Access Compliance Report Public Rights-of-Way (Curb Ramps)

Main Street: DANCING_CLOUD_CT Cross Street: RADIANCE_LN Location: NE

ADA ID: RPRK211019181110 Ramp Type: Type 4 - Parallel Initial Pass/Fail: Pass Overall Compliance: No Severity Score: 22

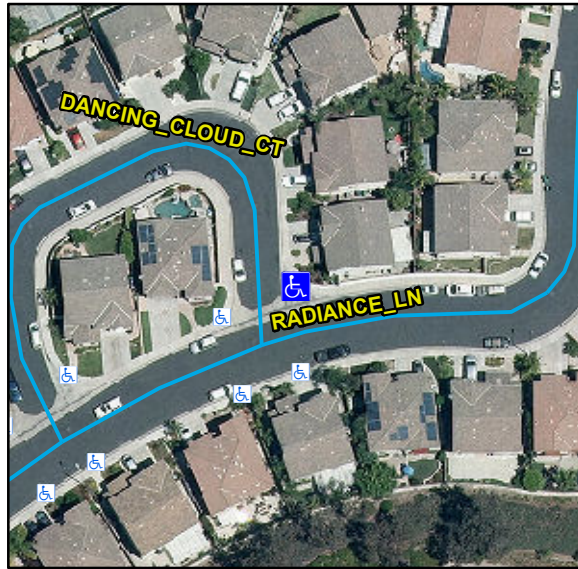
Compliance	Description	Data	Compliance	Description	Data
N/A	Ramp Length LT (in)	112	N/A	Ramp Length RT (in)	116
Yes	Ramp Width LT (in)	48	Yes	Ramp Width RT (in)	48
Yes	Ramp Run Slope LT (%)	4.5	Yes	Ramp Run Slope RT (%)	0.2
No	Ramp Cross Slope LT (%)	2.3	No	Ramp Cross Slope RT (%)	4.1
N/A	Landing Present	No	No	DWS Provided	No
N/A	Landing Length (in)	N/A	N/A	DWS Contrast	N/A
No	Landing Width (in)	N/A	N/A	DWS Length (in)	N/A
No	Landing Run Slope (%)	N/A	N/A	DWS Full Width	N/A
No	Landing Cross Slope (%)	N/A		DWS Offset Type	N/A
N/A	Landing Movement Obstructed?	No	N/A	DWS Offset Left (in)	N/A
	Landing Movement Type	Curb	N/A	DWS Offset Right (in)	N/A
N/A	Landing Shared	N/A			
N/A	Clear Space	Yes			
N/A	Clear Space To Crosswalk (in)	48			
N/A	Marked Crosswalk 1	No	N/A	Marked Crosswalk 2	No
	Crossing 1 Direction	W		Crossing 2 Direction	S
N/A	Marked Crosswalk 1 Width (in)	N/A		Marked Crosswalk 2 Width (in)	N/A
N/A	Ramp Inside Crosswalk 1	N/A	N/A	Ramp Inside Crosswalk 2	N/A

Crossing 1 Slope (%)	4.5		Crossing 2 Slope (%)	2.5
	Crossing 1 Cross Slope (%)	4.3		Crossing 2 Cross Slope (%)	0.6
Yes	Gutter Ponding	No	Yes	Curb Slope	3.4
No	Gutter Lip Height (in)	0.25		Road Run Slope (%)	0.5
Yes	Gutter Run Slope (%)	5		Road Cross Slope (%)	5.6
Yes	Gutter Cross Slope (%)	1.2	No	Perpendicular Joint Present	No
Yes	Overall Surface Condition	Acceptable			
	Cross Gutter Present?	Yes		Spandrel Present?	Yes
	Replace Cross Gutter?	No		Replace Spandrel?	No

Remove & Replace Curb Ramp With Two New Directional Ramps or Equivalent. Grind Gutter Lip.
